# Wastewater Projects Peer Review

Biosolids Project Viability

*City Project No. 15074-121*

City of St. Petersburg

Figure SWWRF-2. Gravity Belt Thickener  
*Southwest WRF*

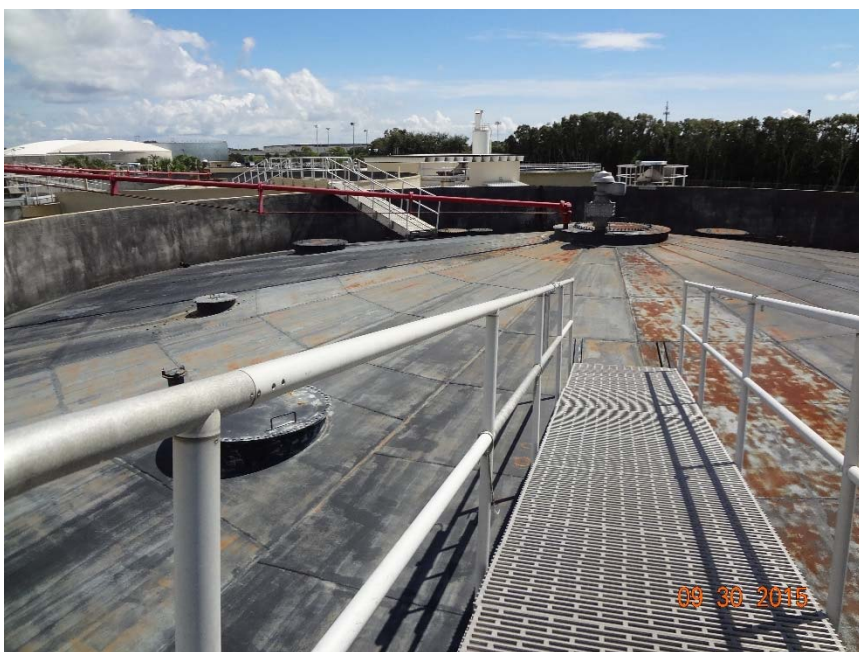
Waste solids are pumped from the secondary treatment process to the Sludge Storage Tank which is in good condition (Figure SWWRF-1). The Sludge Storage Tank is sized to provide operational flexibility, but it not large enough to store solids if a downstream process were out of service for an extended [eriod]. The thickening facility is located in the Gravity Belt Thickener (GBT) Building in the northwest portion of the plant site adjacent to the anaerobic digesters (Figure SWWRF-2). The GBT Building is open on the sides and includes one Ashbrook GBT and auxiliary equipment. The building and equipment is in moderate condition. The current biosolids treatment process does not require thickening, but operations continues to maintain this facility for future use. The City has indicated that a second GBT will need to be installed to meet demand and serve as a backup.

Figure SWWRF-8. Bioset System  
*Southwest WRF*

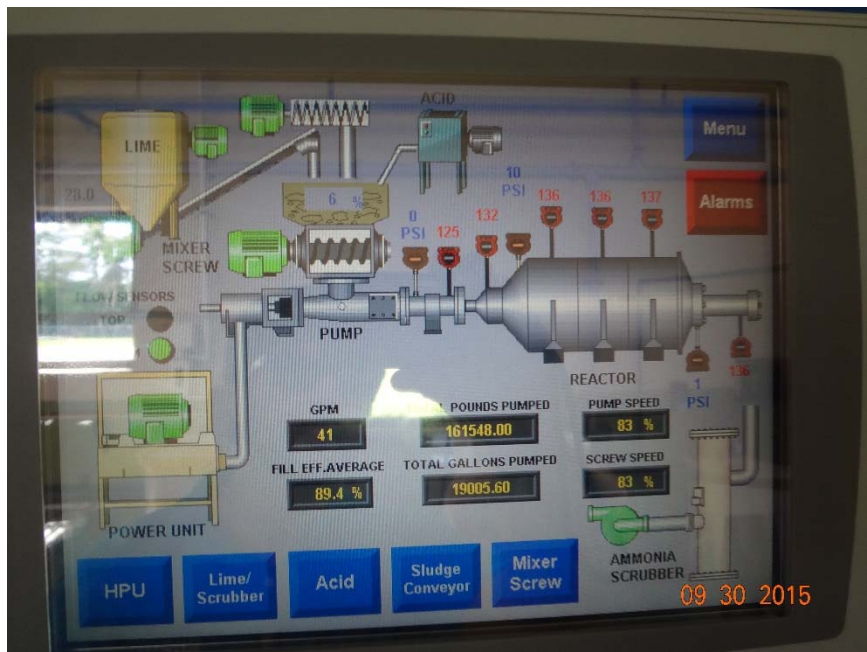
A Bioset system was installed at SWWRF in 2012 as an interim replacement of the treatment capacity of the failing digesters before the new digesters as part of the Biosolids to Energy Project. The Bioset process operates between 10-12 hours per day, seven days a week by adding lime to the dewatered sludge which maintains elevated temperature and pH levels in order to stabilize the biosolids (Figure SWWRF-8 and SWWRF-9). The Bioset process has been approved to produce Class A biosolids. Operations indicated that this process and the low metals present in the raw wastewater allow SWRF to produce a Class AA biosolid. The addition of the Bioset reactor as part of the conveyance upgraded a portion of the truck loading area which overall appeared in moderate to good condition.
